Safety Bulletin

No: SB040

Description: EMI 400 Blower Motor
Mounting Plate

LeTourneau TECHNOLOGIES™ POWER SYSTEMS DRILLING SYSTEMS	Product Bulletin	LTI-PB-MTR-001
		Rev. 01
		Issued Date: 6/19/08
		Page 4 of 4

Figure 1 – (a) Blower motor mounting plate, (b) plate thickness

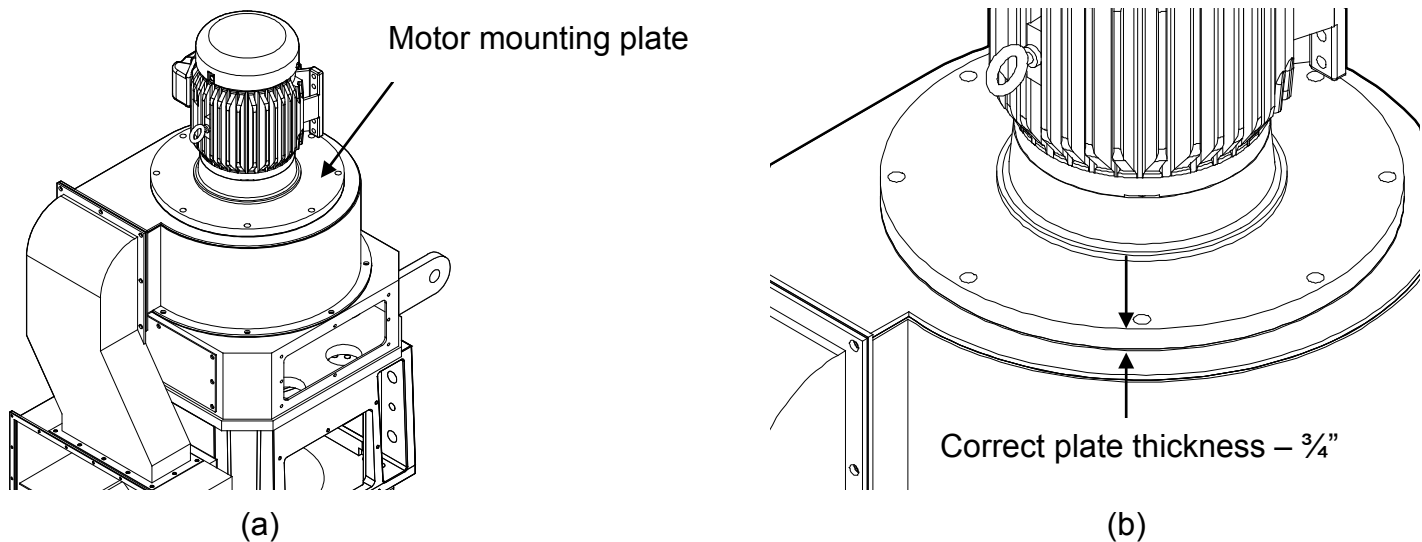
An incident occurred where the blower motor on an LTI TT400 induction motor became detached from its mounting plate (see Figure 1b). These motors are built by LeTourneau Technologies, Inc. (LTI) and can be identified as such on the motor data plate. A subsequent incident investigation determined that LTI had occasionally substituted a mounting plate of insufficient thickness which prevented the motor from being tightly bolted to the mounting plate. This left the motor slightly loose and able to vibrate during operation leading to failure of the motor mounting bolts and eventual detachment from the mounting plate. Additional details are provided in the attached LTI Product Bulletin LTI-PB-MTR-001.

1. Inspect and measure the blower motor mounting plate thickness as shown in Figure 1b.
2. If plate thickness is less than $\frac{3}{4}$ " nominal, remove from service and contact your local TESCO representative to order a replacement motor mounting plate.
3. If applicable replace motor mounting plate. Ensure thread locking compound and safety wires are replaced as necessary.

3.0 Fix: The fix is to first determine if the plate is of proper thickness. Measure the plate to assure it is of 3/4" nominal size. If it is less than 3/4" remove from service and replace with LTI replacement part prior to being placing top drive back in service.

DAMAGED
BLOWER MOUNT
PLATE

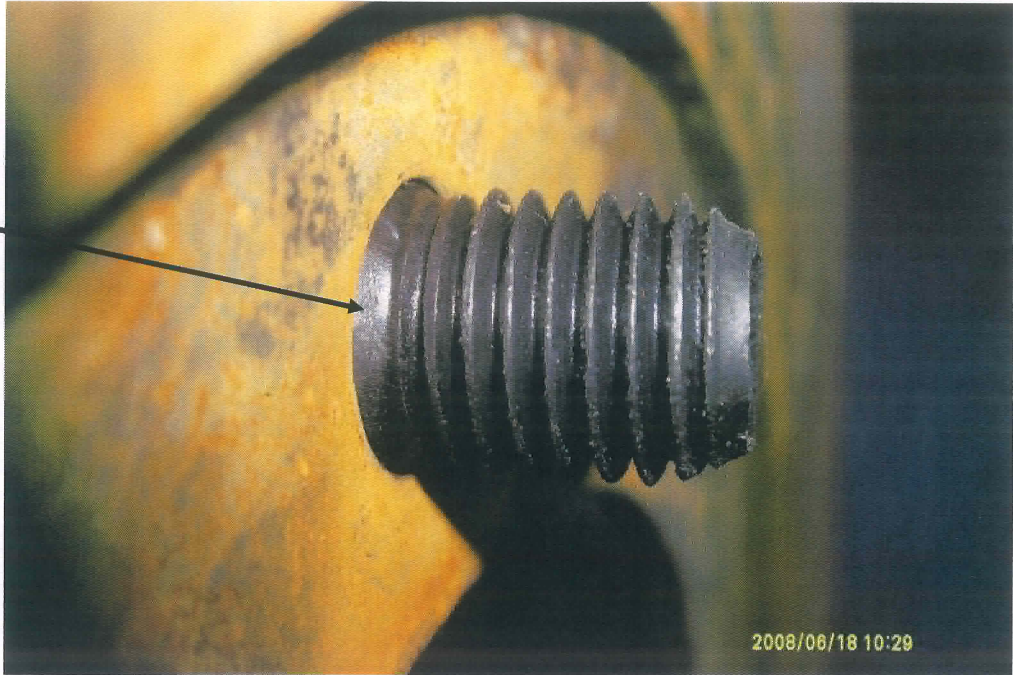
2.0 Issue: The mounting plate supplied with some Tesco 400HP motors was of insufficient thickness. In some models the countersunk fasteners that attach the blower motor do not seat against the plate when fully tightened. This causes the blower motor to vibrate freely and damage the mounting plate and possibly shear the bolts. **The result is that the blower motor may become loose and present a falling object hazard to personnel.**

Protruding countersunk head prevents secure attachment of the blower motor.

Action(s): STOP USE IMMEDIATELY; CEASE USE UNTIL INSPECTION IS COMPLETED; Identify the blower plate type. If it is less than 3/4" remove from service and contact Le Tourneau Technologies Drilling Systems, Inc. field service department (Joe Hope, Engineer Manager 713-983-4811) for part number OEM4010A-K011 for a direct replacement. Replace with replacement part prior to being placed back in service.

REMOVE FROM SERVICE
-TOO THIN

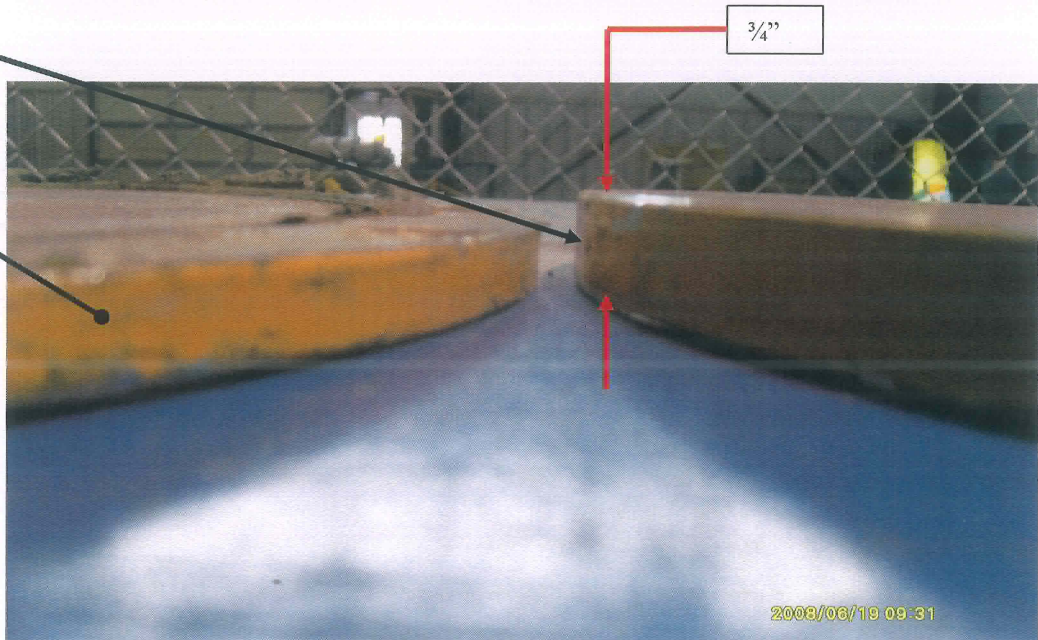
OK FOR SERVICE
